PLANNING COMMISSION MEETING AGENDA
FEBRUARY 20, 2024
5:30 PM
ONLINE VIEWING:
PLANNING COMMISSION: HTTPS://US02WEB.ZOOM.US/J/88638737828
BOARD OF ADJUSTMENT: HTTPS://US02WEB.ZOOM.US/J/88638737828
ZONING REVIEW COMMITTEE: HTTPS://US02WEB.ZOOM.US/J/87985050090

RZN/DCP: The Hamilton

VAR: Meadows Development

Rezone/DCP

DCP-1

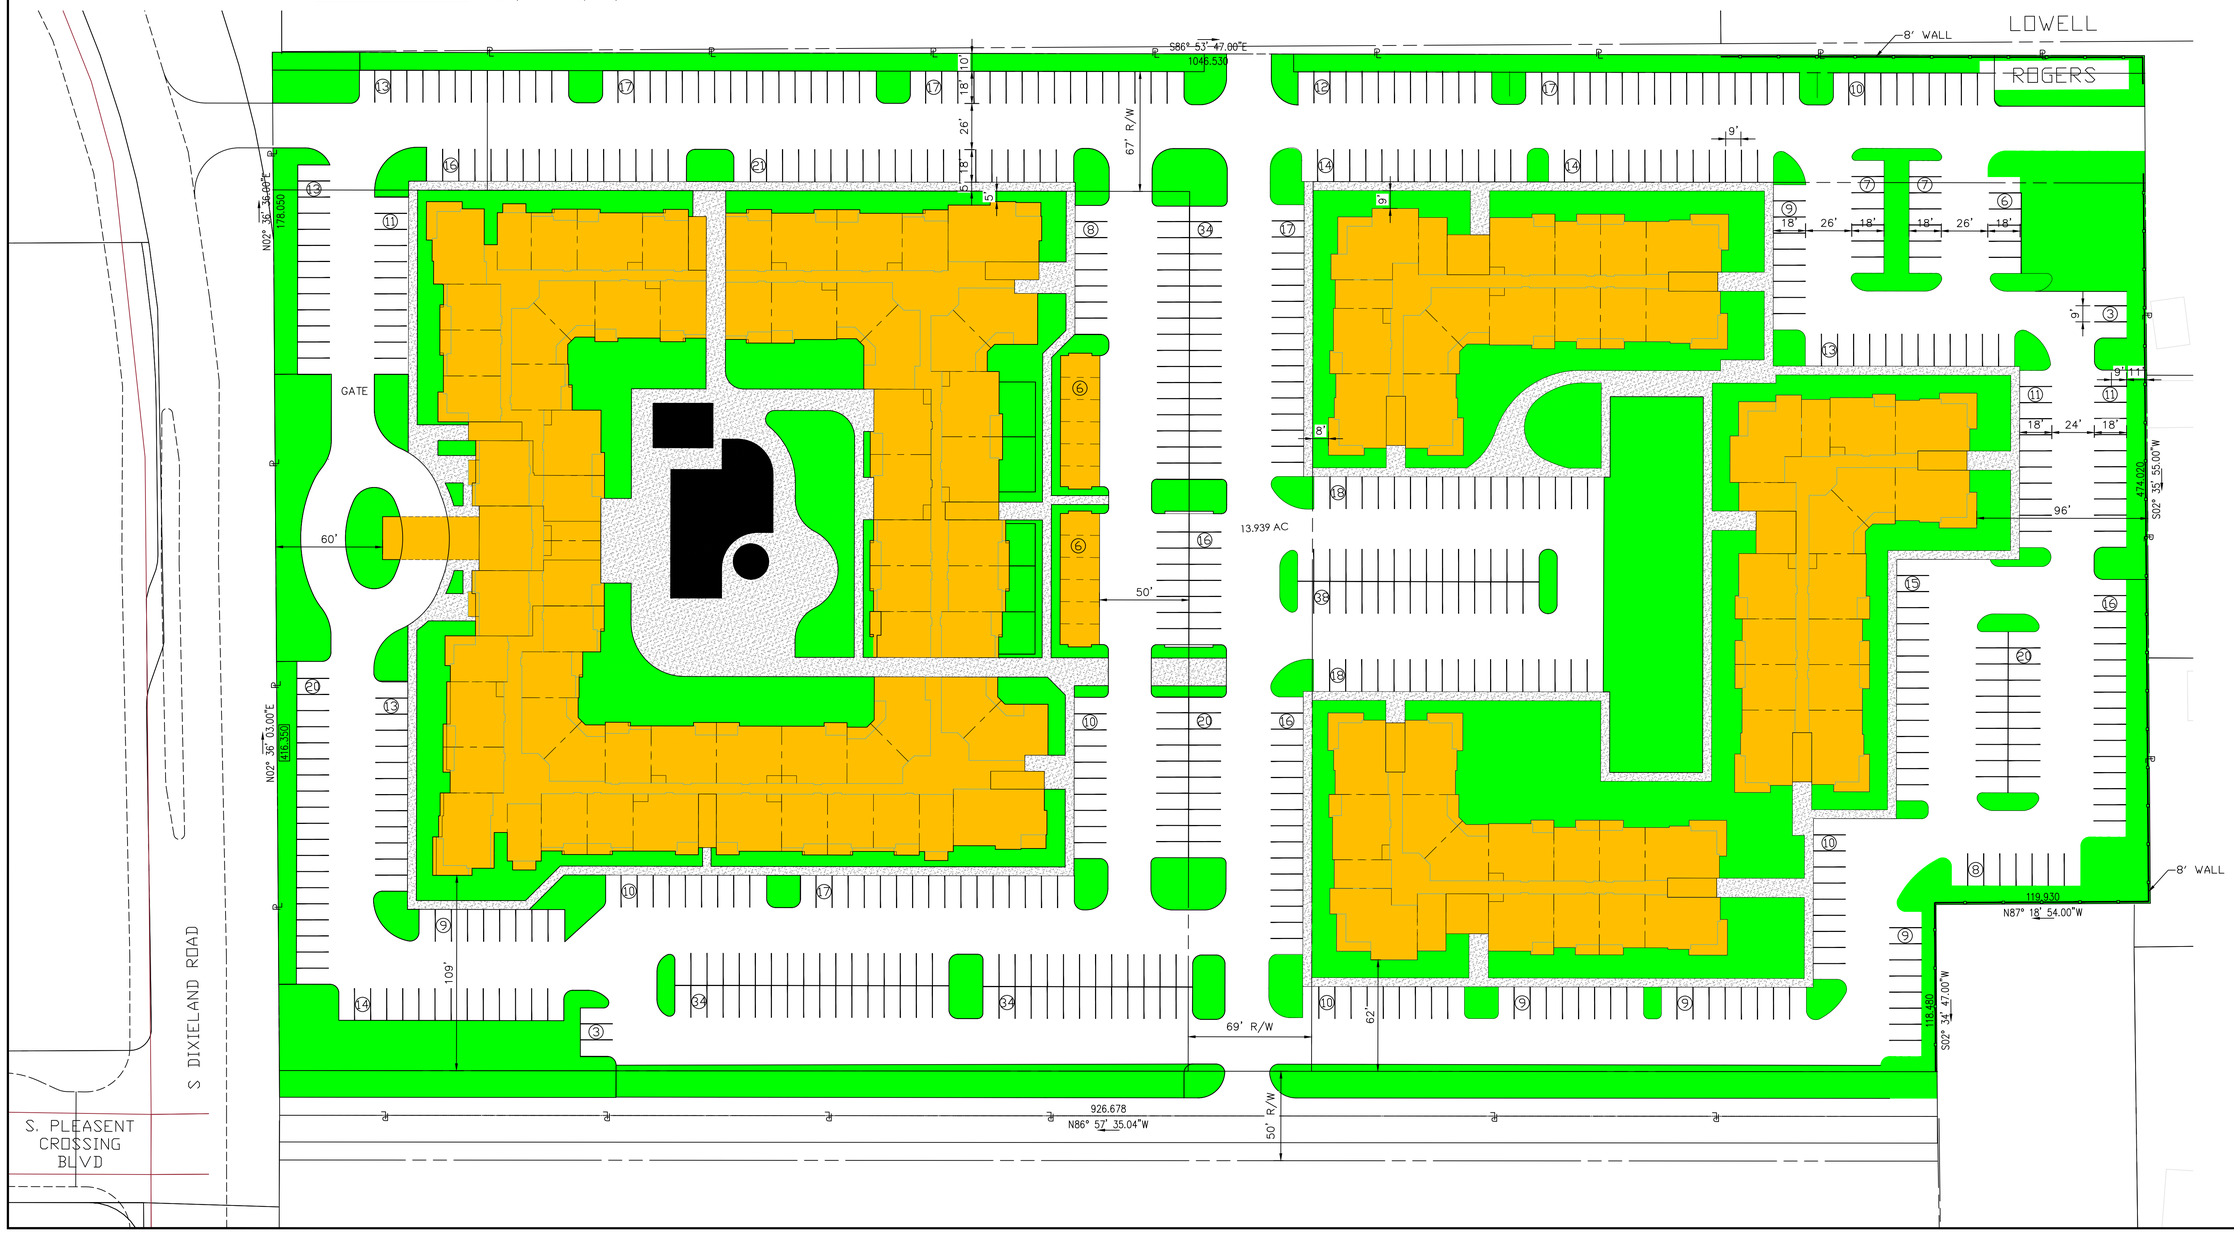
- Staff has recently come across proposals on undeveloped parcels to the north (Lowell) and south (Rogers).
- Staff wants to ensure that proposed road connections line up and create a seamless transition between sites in our continued effort to create a grid network.
- Due to this, staff would like more time to work with the applicant. This has been discussed with the applicant and they are in agreement.

Engineering:
Right-of-way dedication to be required at the intersection of S. Dixieland and S. Pleasant Crossing for a planned round-a-bout.

Risk Reduction:
Ensure that appendix D (105.2 and 105.3) are met in regards to width and aerial access in proximity to building. East side of property layout will be difficult to navigate with fire department apparatus.

Rogers Water Utilities:
A downstream sewer study will be required with any development on this site. Connections to the public water system must be through two independent locations to create a redundant supply for the project.

We are requesting a postponement to the 4/2/24 pc meeting. The justification is rooted in having time to rework the site plan to be consistent with adjacent sites as requested by staff.

Setback Request

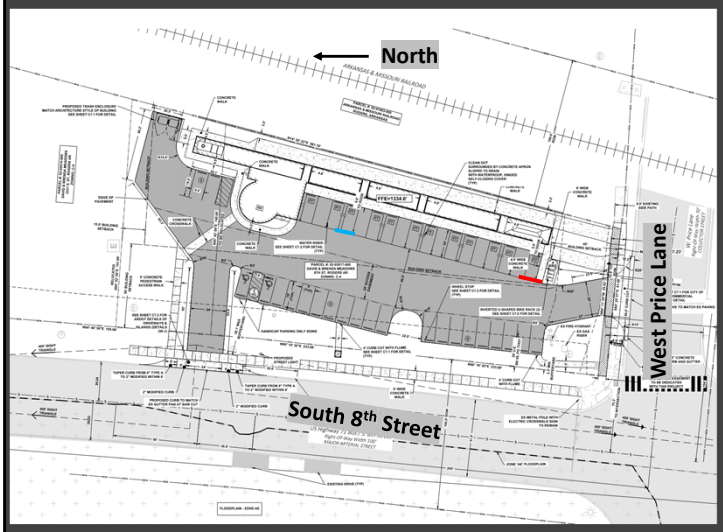
- To vary from the front 75' setback requirement
- The applicant is proposing a 56' setback at the closest point (outlined in red) for the canopy structure to be proposed over the food trucks
- As the proposed canopy shifts northeast with the site, the canopy falls outside of the 75' setback (outlined in blue)

- The applicant is proposing a setback reduction of, at most, 19' down to 56' (outlined in red) for the canopy hanging over the food trucks.
- The blue outline shows where the canopy would begin to fall outside of the 75' setback.

Setback Analysis

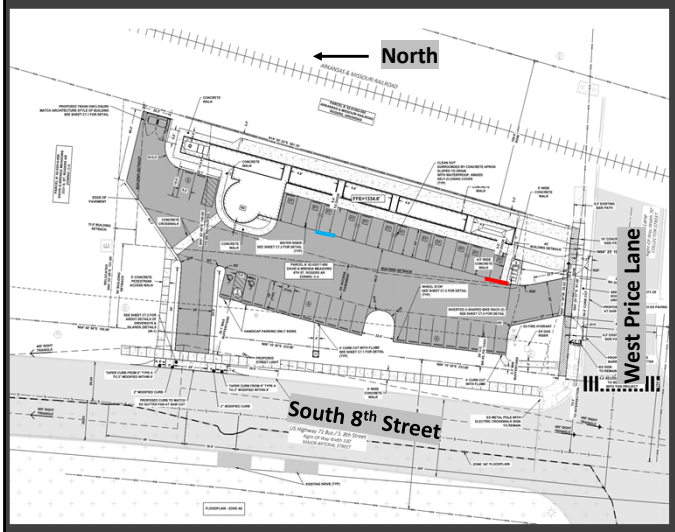
- Sec. 14-284(a): "The purpose of the overlay district is to protect and enhance the scenic quality of the City's highways and primary corridors designated below, create design standards for developments, and provide effective land use planning and facilitate traffic flow."
- While the existing lot dimensions of the site do pose restrictions, the owner of this lot owns the property to the north as well. The applicant is proposing to shift the north property line further north with this proposal. The north property line could be shifted even further to the north or the lots could be combined to allow for the development to shift northeast outside of the front setback.

Bufferyard Request

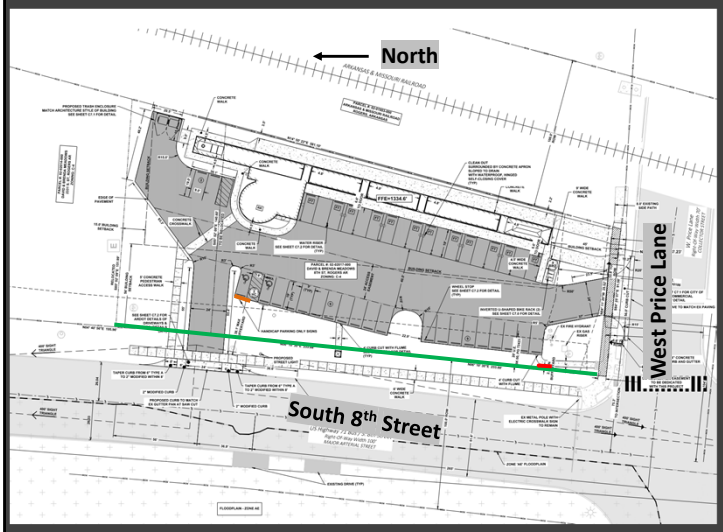
- To vary from the 25' front bufferyard requirement (measured from the right-of-way, outlined in green)
- The applicant is proposing 2.3' of bufferyard at the least (outlined in red)
- As the parking shifts northeast with the site, the bufferyard does begin to meet the 25' requirement (outlined in orange)

- The applicant is requesting a reduction in the Overlay District front bufferyard requirement from 25' to, at the least, 2.3'.
- As the parking shifts northeast, the bufferyard does begin to meet the 25' requirement.

Bufferyard Analysis

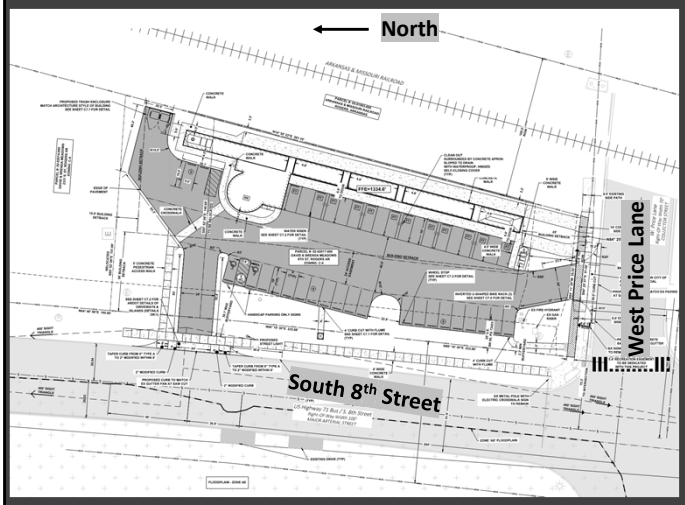
- Sec. 14-284(a): "The purpose of the overlay district is to protect and enhance the scenic quality of the City's highways and primary corridors designated below, create design standards for developments, and provide effective land use planning and facilitate traffic flow."
- While the existing lot dimensions of the site do pose restrictions, the owner of this lot owns the property to the north as well. The applicant is proposing to shift the north property line further north with this proposal. The north property line could be shifted even further to the north or the lots could be combined to allow for the development have enough space to meet the bufferyard requirements.

Frontage Tree Plantings Request

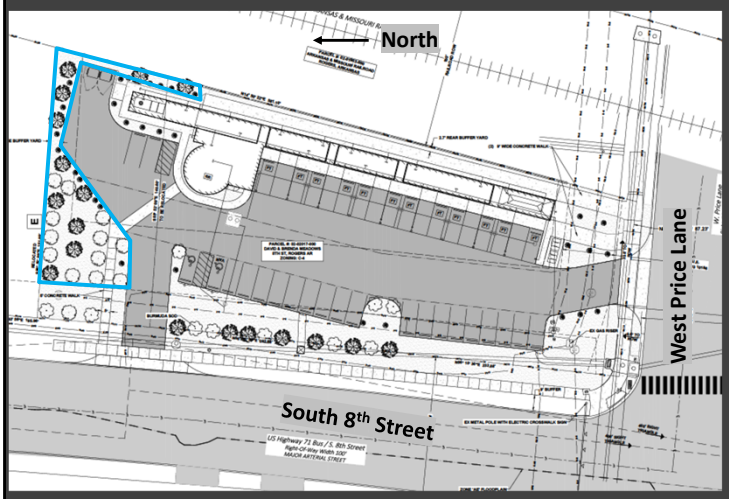
- To vary from the requirement to plant trees at 20' spacing (15 trees) within the 25' bufferyard
- The applicant is proposing the planting of the 15 Overlay Trees, in addition to site landscaping requirements, within the interior portion of the site (outlined in blue).
- The trees seen within the 25' bufferyard along South 8th are proposed street trees.

- The applicant is requesting to vary from the requirement to plant trees at 20' spacing within the 25' bufferyard.
- Instead, the applicant proposes planting the required 15 Overlay Trees within the site.

Frontage Tree Planting Analysis

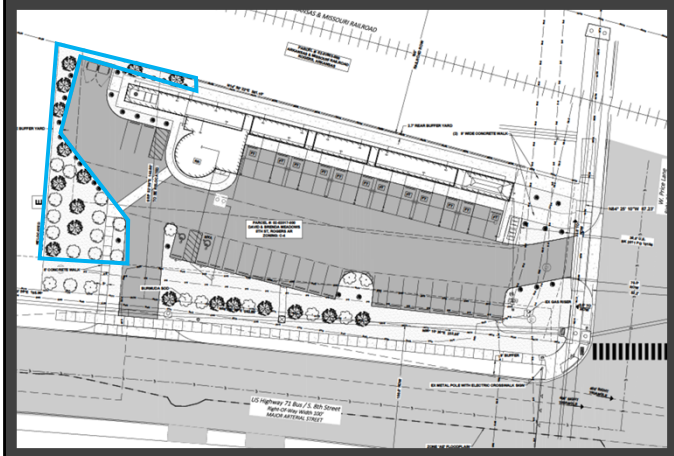
- Sec. 14-284(a): "The purpose of the overlay district is to protect and enhance the scenic quality of the City's highways and primary corridors designated below, create design standards for developments, and provide effective land use planning and facilitate traffic flow."
- While the existing lot dimensions of the site do pose restrictions, the owner of this lot owns the property to the north as well. The applicant is proposing to shift the north property line further north with this proposal. The north property line could be shifted further to the north or the lots could be combined to allow for the development to have more space for the Overlay Trees within the 25' bufferyard.

Frontage Tree Planting Analysis

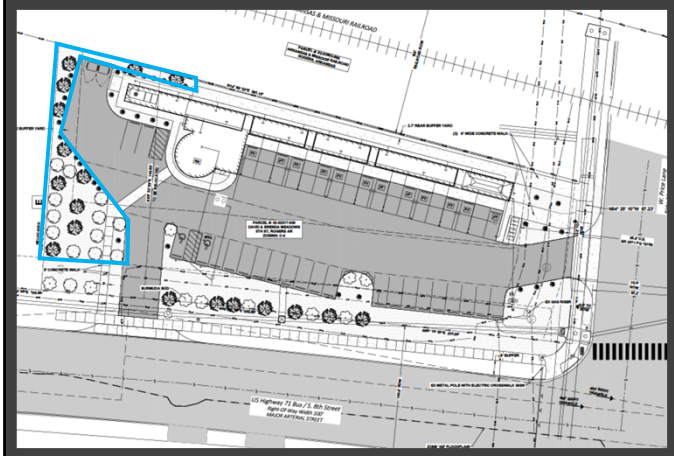
- The applicant is also not providing a stub-out to the north for cross-access which is required. This would result in the removal of some of the trees as shown.
- If the board wishes to grant this tree planting variance, staff recommends requiring shrubs to be planted along the front of the parking.
